1.0 SAFETY LIMITS AND LIMITING SAFETY SYSTEM SETTINGS

2.0 LIMITING CONDITIONS FOR OPERATION
 2.10 Reactor Core (Continued)
 2.10.4 Power Distribution Limits
 (Continued)

JUSTIFICATION

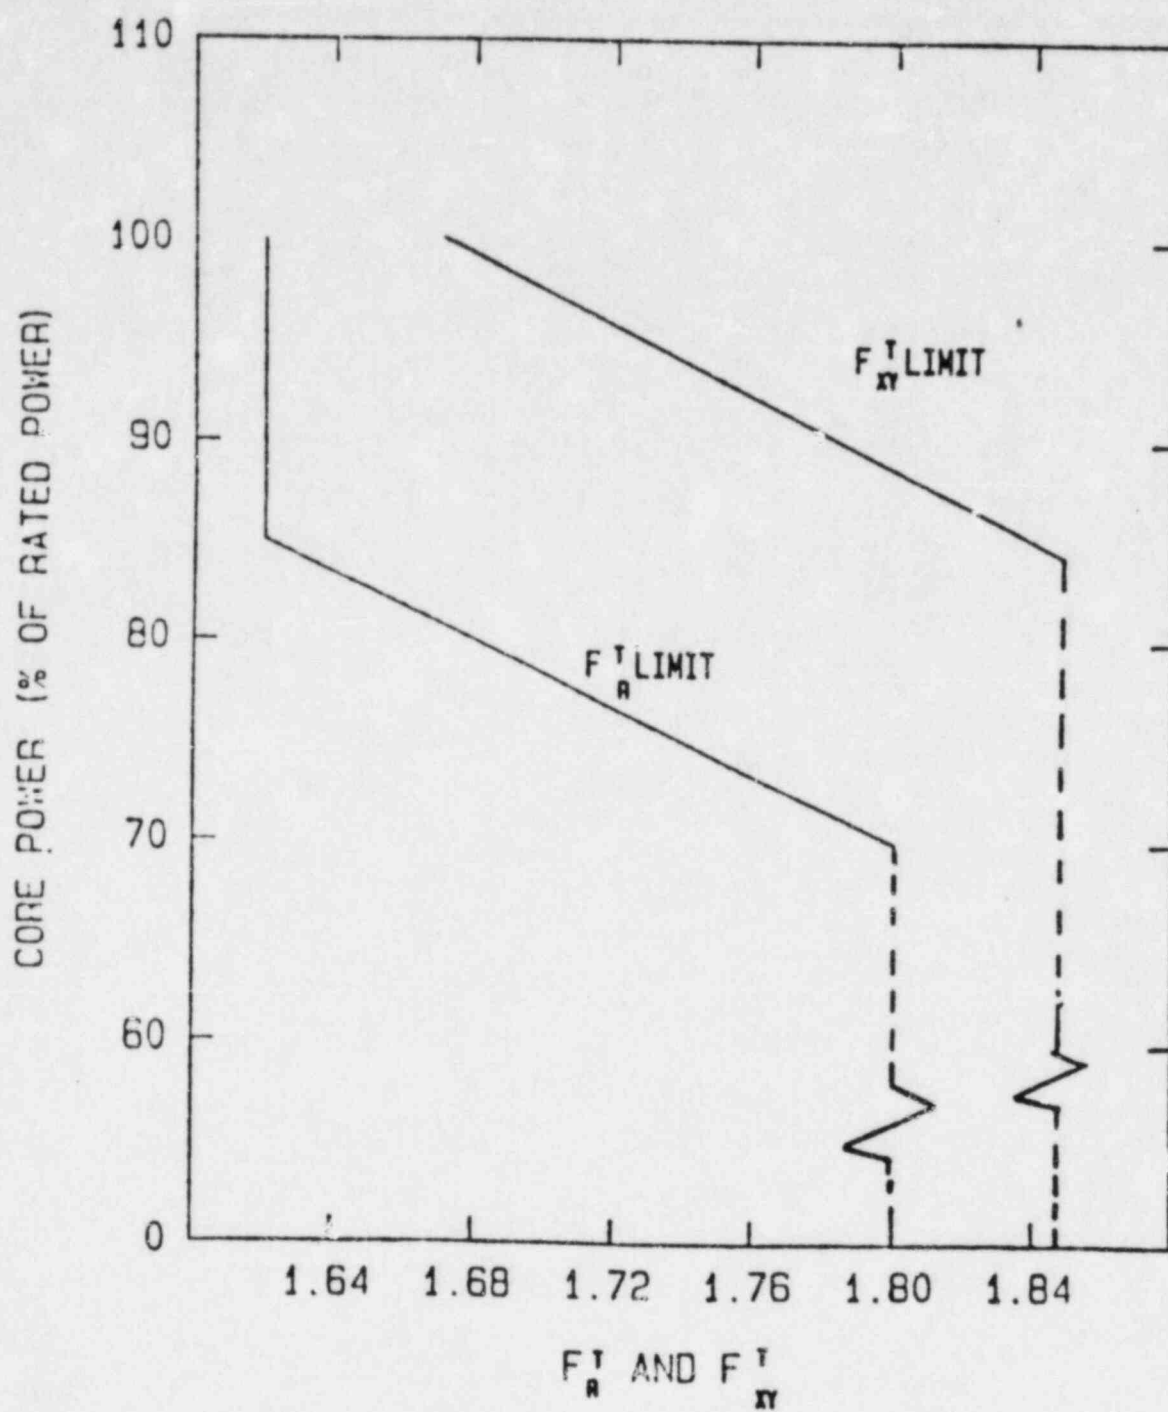
The calculated value of F_{xy}^T defined as $F_{xy}^T = F_{xy} (1+T)$ shall be limited to ≤ 1.67 . F_{xy} is determined from a power distribution map with no part length CEA's inserted and with all full length CEA's at or above the Long Term Steady State Insertion Limit for the existing Reactor Coolant Pump combination. The azimuthal tilt, T , is the measured value of T_q at the time F_{xy} is determined.^q

With $F_{xy}^T > 1.67$ within 6 hours:

- (a) Reduce power to bring power and F_{xy}^T within the limits of Figure 2-9, withdraw the full length CEA's to or beyond the Long Term Steady State Insertion Limits of Specification 2.10.2(7), and fully withdraw the PLCEA's, or
- (b) Be in at least hot standby.

All safety analyses and Technical Specifications were shown to be valid for these higher peaking factors with the exception of the Technical Specification on the Total Planar Radial Peaking Factor (F_{xyT}) and the F_{xyT} versus Core Power Limitations of Figure 2-9. To assure the validity of the Cycle 8 safety analysis, it is necessary to reduce the F_{xyT} limitation to 1.67 and revise Figure 2-9 for this lower limit.

The early shutdown of the Cycle 7 core resulted in an end-of-cycle burnup of 9725 MWD/T rather than the design value of 10,500 MWD/T. The early shutdown necessitated a verification of the Cycle 8 safety analysis to assure its validity for this lower Cycle 7 burnup. The lower Cycle 7 exposure resulted in an increase in the predicted values of the bank 4 inserted values of F_R and F_{xy} . To account for these increases, it was necessary to increase the values of the bank 4 inserted radial peaking factors used in the Cycle 8 safety analysis. The bank 4 inserted value of F_R used in the safety analysis is increased from 1.61 to 1.65 and the bank 4 inserted value of F_{xy} used in the safety analysis is increased from 1.69 to 1.74.

No operating problems are anticipated with lowering the allowable F_{xyT} value since the predicted value of F_{xy} is less than the proposed limit.
